**UBWR Revised Responses to Comments of the  
U.S. Bureau of Land Management and National Park Service on  
the Lake Powell Pipeline Final License Application Documents  
(January 17, 2019)**

Revised Responses to  
U.S. Bureau of Land Management Comments  
On the Lake Powell Pipeline  
Final License Application Documents  
January 17, 2019

Revised Responses to  
National Park Service Comments  
On the Lake Powell Pipeline  
Final License Application Documents  
January 17, 2019

**Figure 5-94D. Glen Canyon Dam Release Temperature Percentiles for the LPP Proposed Action Under Climate Change**

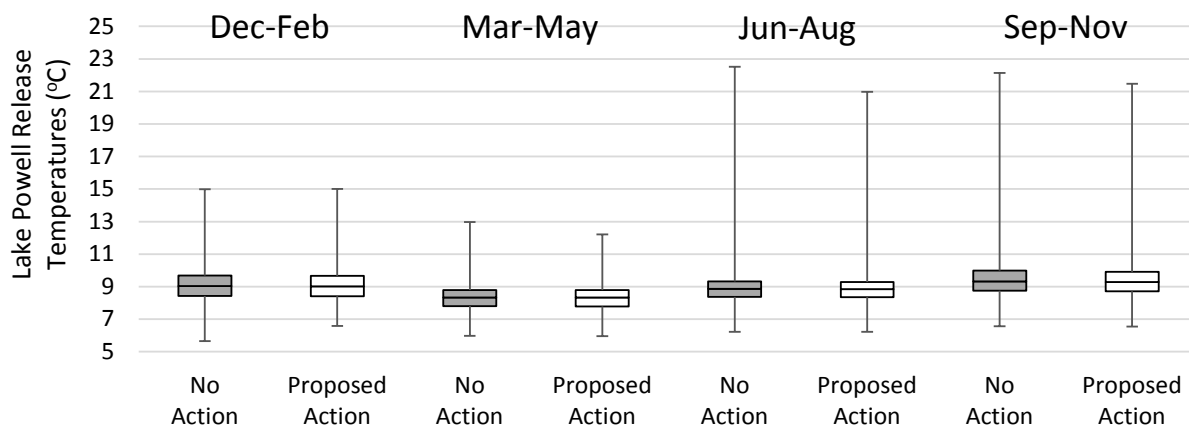
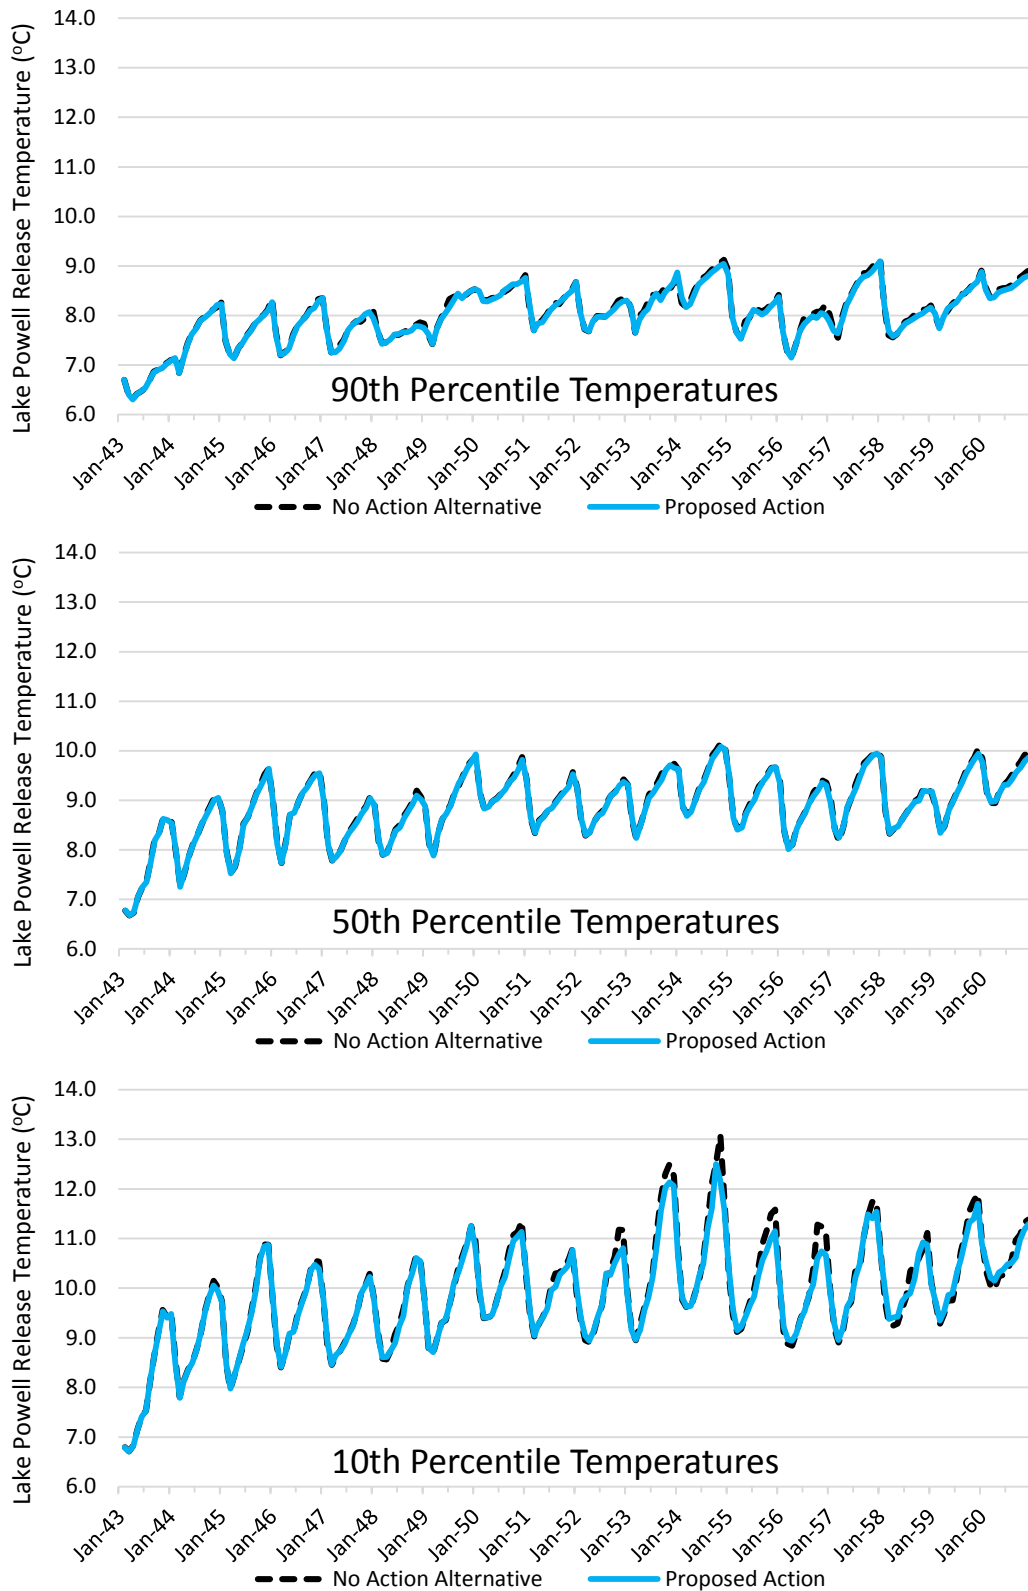
Low reservoir elevations below Lake Powell's normal operating range, resulting from 10th percentile climate change inflow hydrology conditions as modeled by Reclamation, would be lowered further by the combination of the LPP Proposed Action depletions and one or more of the listed interrelated actions. The climate change inflow hydrology would be the primary cause of the lowered reservoir elevation in Lake Powell, and the combination of LPP depletions and one or more of the other interrelated actions would further lower the reservoir level by 1.7 feet at the 10th percentile of climate change inflow conditions. Cumulative effects on surface water quality in Lake Powell would include increased and decreased water temperatures (Figure 5-94C), decreased

dissolved oxygen concentrations, and increased TDS concentrations. These cumulative effects would be significant.
